**DOCUMENT 00 90 00
ADDENDUM**

ADDENDUM NO. [1] Date: February 17, 2020

**RE: WESTERN TECHNICAL COLLEGE
 APPRENTICESHIP CENTER REMODEL
 2860 21ST PLACE SOUTH
 LA CROSSE, WISCONSIN 54601
 HSR PROJECT NO. 19021**

This Addendum consists of [2] page, [1] specification sections and [9] 30 x 42 drawings.

1 PLUMBING ENLARGED UNDERFLOOR PLAN
1/4" = 1'-0"

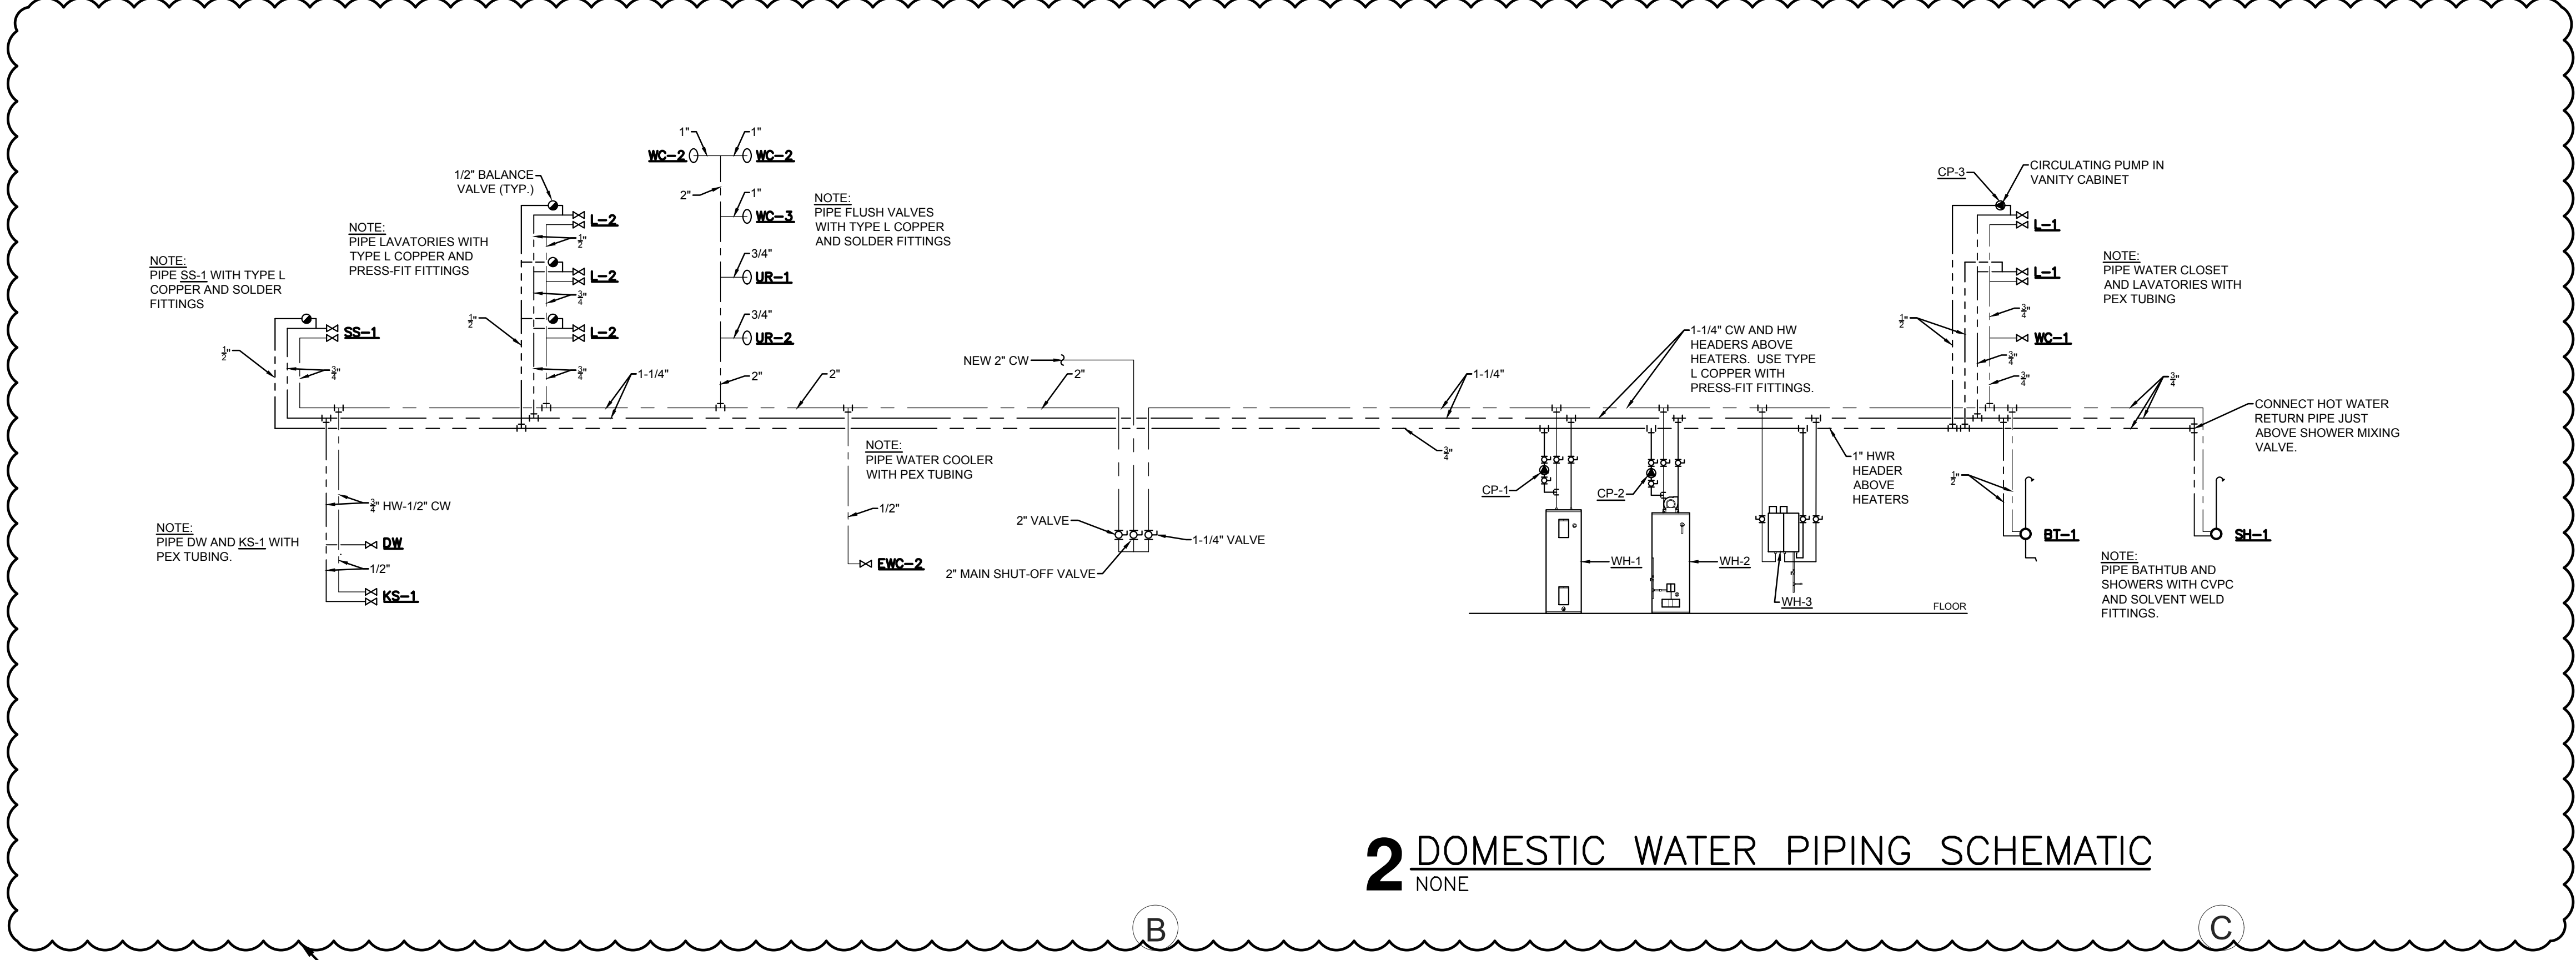
- a. Revisions clouded on Drawing.
10. Sheet P200 PLUMBING ENLARGED UNDERFLOOR PLAN 30 x 42 attached hereto.
 - a. Revisions clouded on Drawing.
11. Sheet P201 PLUMBING ENLARGED FIRST FLOOR PLAN 30 x 42 attached hereto.

1 PLUMBING ENLARGED FIRST FLOOR PLAN
1/4" = 1'-0"

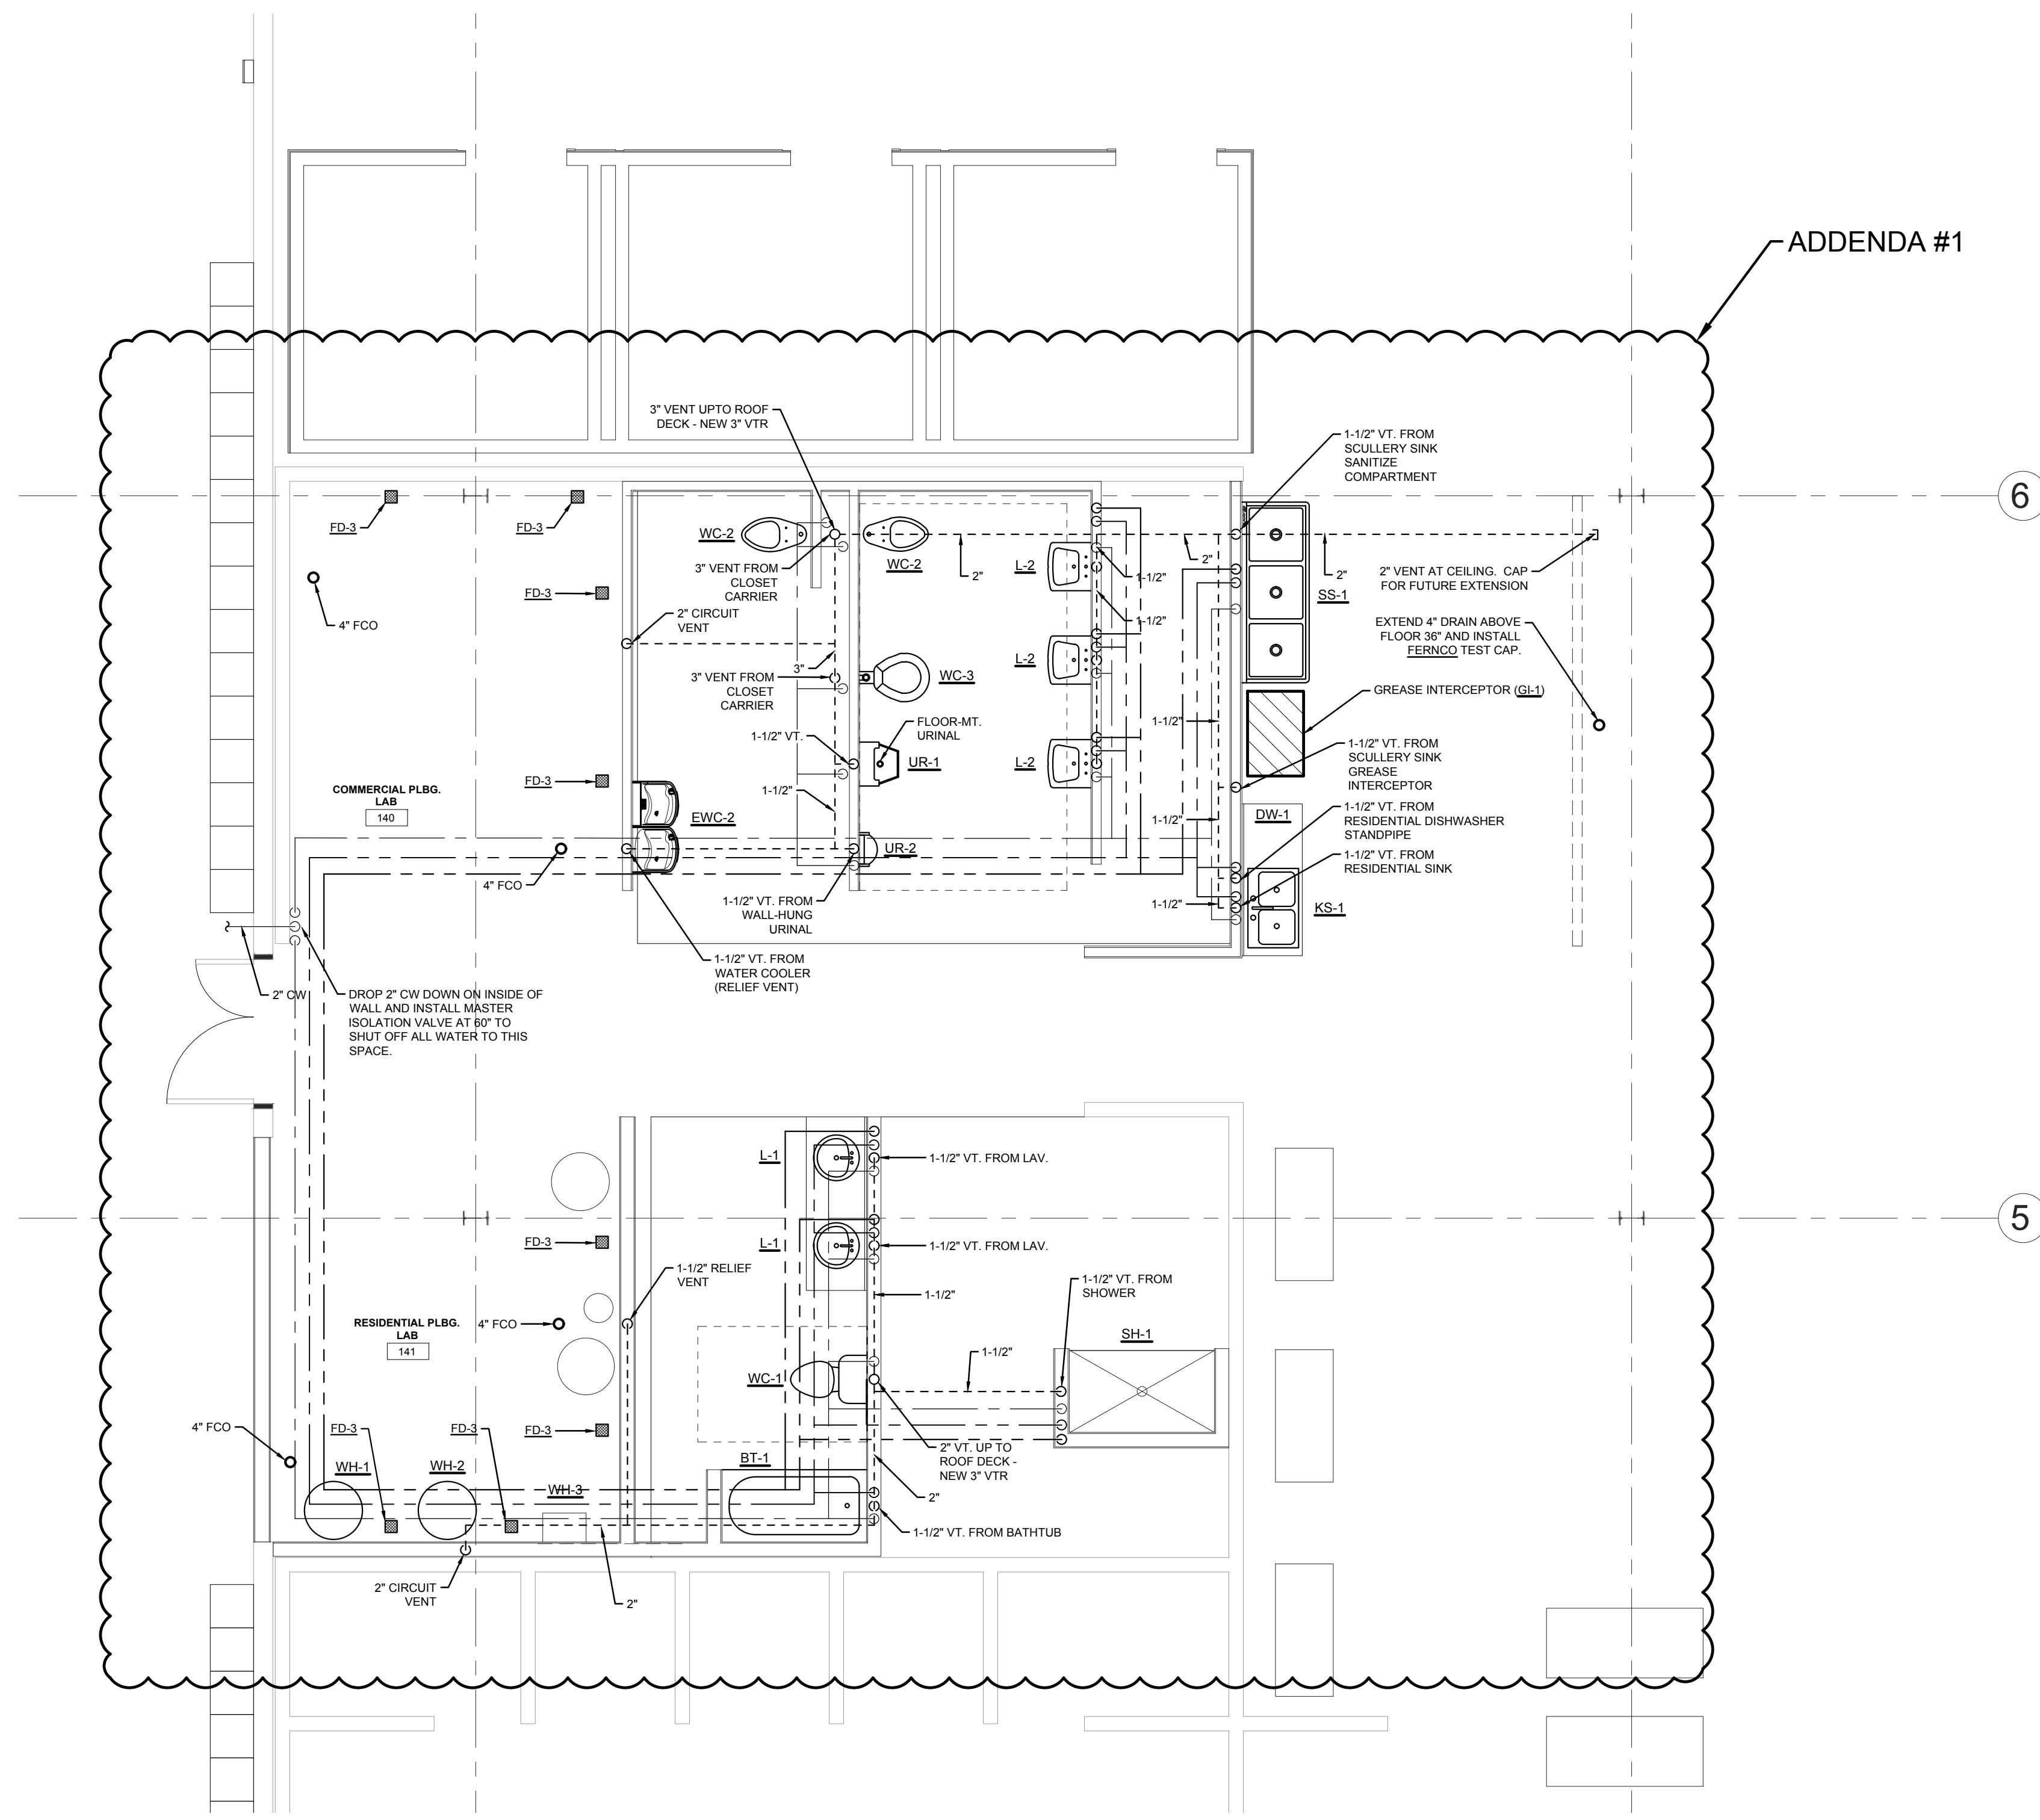
- a. Revisions clouded on Drawing.
12. Sheet E202R ENGLARGED POWER PLAN 30 x 42 attached hereto
 - a. Revisions clouded on Drawing.
